NOTICE OF DECISION

DECISION OF THE PLANNING COMMISSION

**CLASS 3 DESIGN REVIEW / CLASS 3 SITE PLAN REVIEW / CLASS 2
ADJUSTMENT / CLASS 2 DRIVEWAY APPROACH PERMIT CASE NO DR-SPR-
ADJ-DAP19-06**

SUMMARY: Proposed development of a new four-unit residential apartment complex.

TENTATIVE SITE PLAN

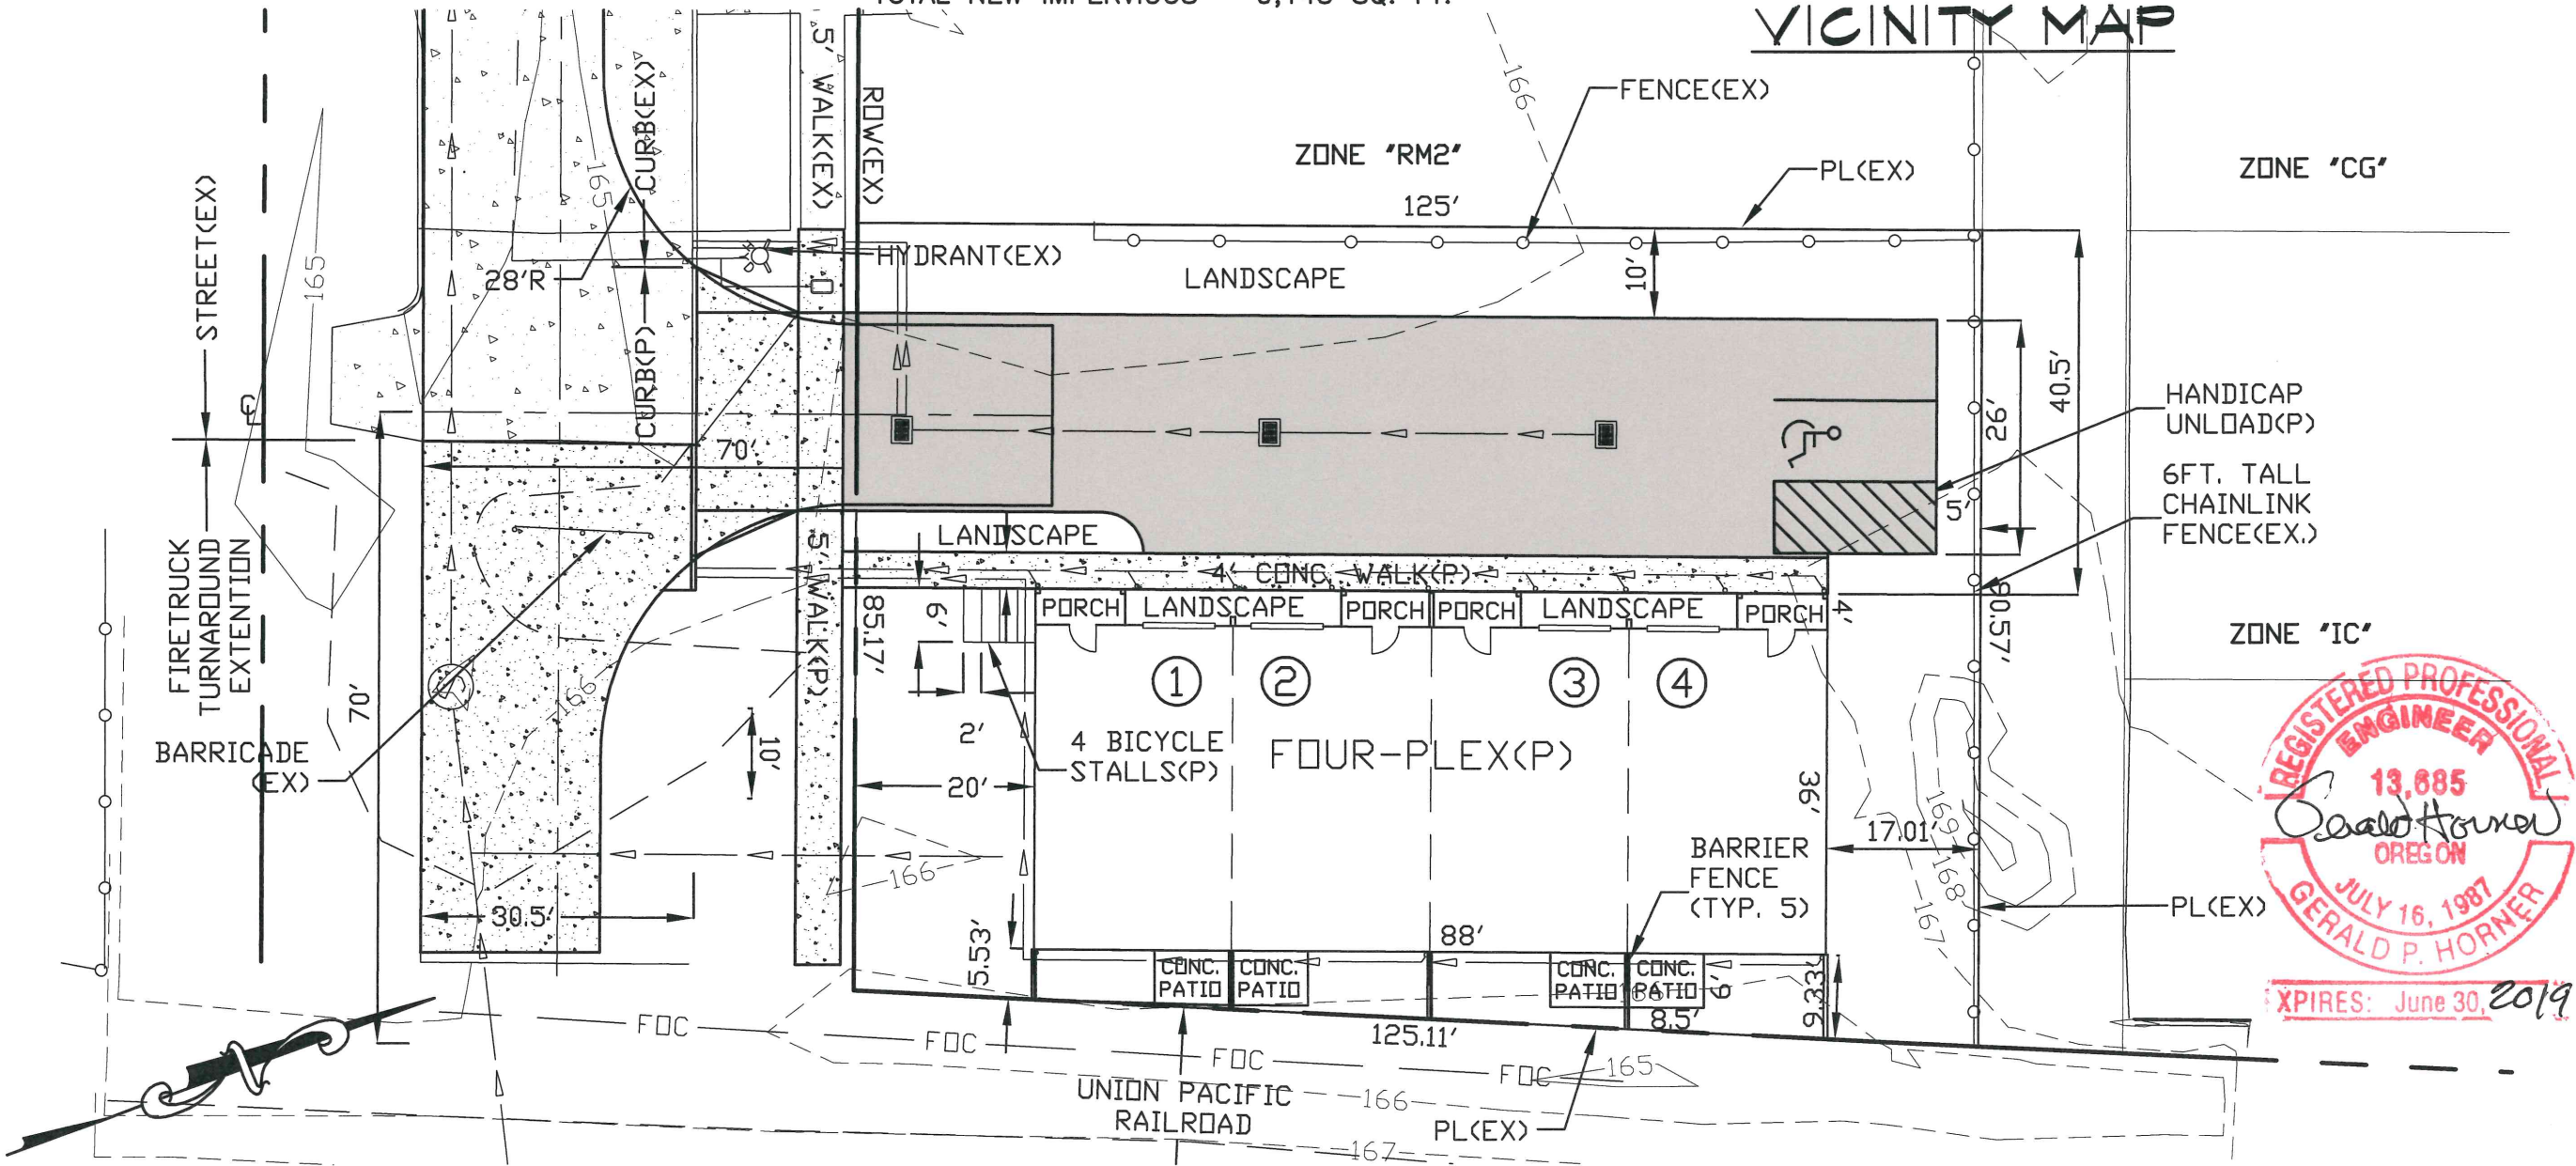
Condition 2: ~~Construct a hammerhead turnaround to Public Works standards within the right of way of Jefferson Street NE.~~

Provide a three-quarter boundary street improvement along Jefferson St NE.

The Grant Neighborhood Association indicated concerns with the applicant's proposal to provide a hammerhead turnaround to Public Works standards within the right-of-way for Jefferson Street NE and requested that the street improvement be widened to provide additional on-street parking options for residents and visitors of the proposed four-unit apartment complex. The Planning Commission finds that a three-quarter boundary street improvement along Jefferson Street NE would provide the additional on-street parking opportunities requested by the Grant Neighborhood Association.

Condition 2: Provide a three-quarter boundary street improvement along Jefferson Street NE.
